Technical Service Information

THM 4L60 (700-R4) NEW FRONT PUMP BODY

Figure 1

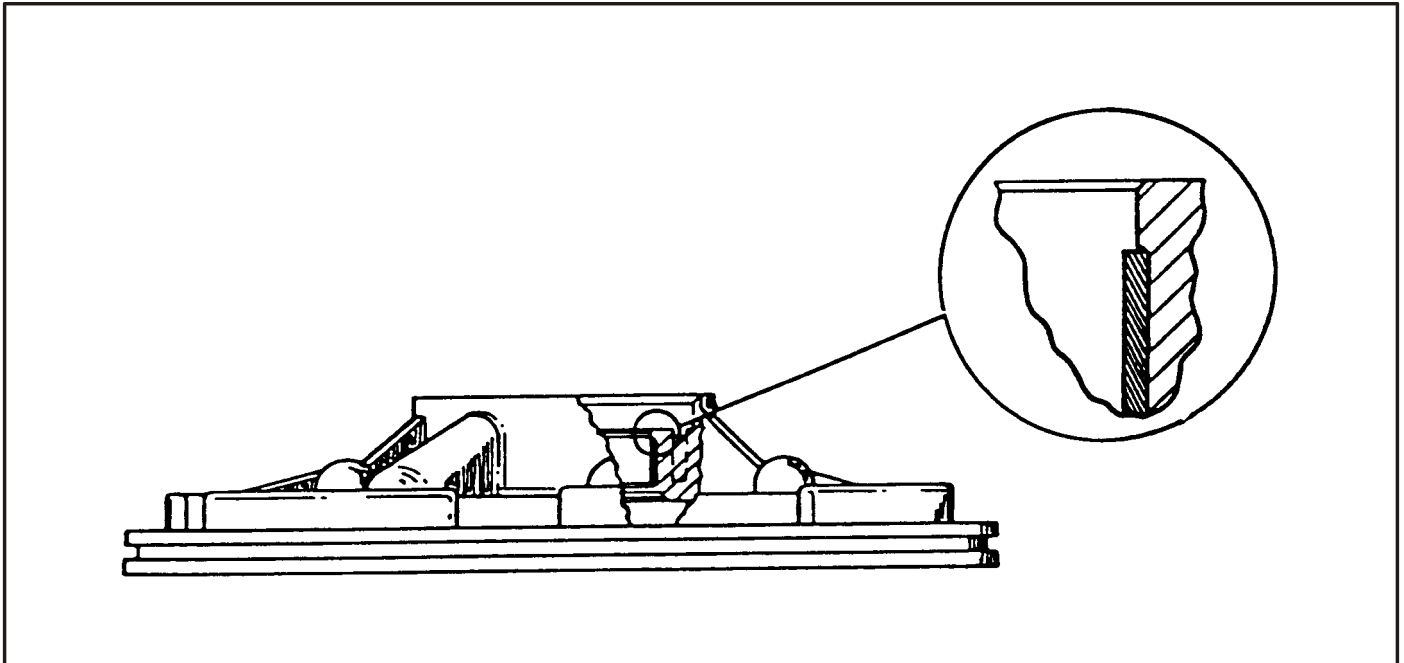
Beginning January 9, 1987 (Julian Date 009), there was a machined step added to the pump bushing bore in the pump body, to prevent the bushing from "Walking" towards the front pump seal (See Figure 1).

Because of the step added to the bore in the pump body, removal and installation procedures must be revised. The bushing must now be "Pressed Out" towards the pump rotor side, and "Pressed In" from the pump rotor side.

Care must be used when pressing the new bushing in, so as not to exert too much pressure, and break the added step in the pump bushing bore. Refer to Figure 1.
